PIC18F2515/2610/4515/4610 Rev. A3 Silicon Errata

The PIC18F2515/2610/4515/4610 Rev. A3 parts you have received conform functionally to the Device Data Sheet (DS39636D), except for the anomalies described below. Any Data Sheet Clarification issues related to the PIC18F2515/2610/4515/4610 will be reported in a separate Data Sheet errata. Please check the Microchip web site for any existing issues.

The following silicon errata apply only to PIC18F2515/2610/4515/4610 devices with these Device/Revision IDs:

FIGURE 1: SCK PULSE VARIATION USING TIMER2/2

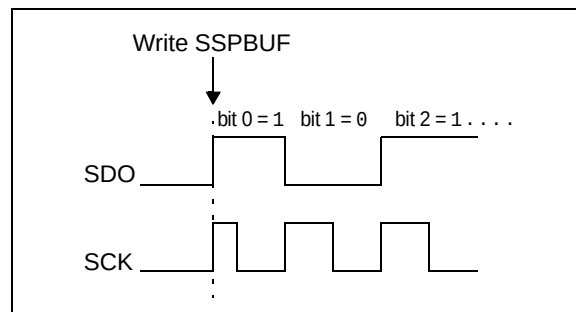
When the SPI is using Timer2/2 as the clock source, a shorter than expected SCK pulse may occur on the first bit of the transmitted/received data (Figure 1).

To avoid producing the short pulse, turn off Timer2 and clear the TMR2 register, load the SSPBUF with the data to transmit and then turn Timer2 back on. Refer to Example 6 for sample code.
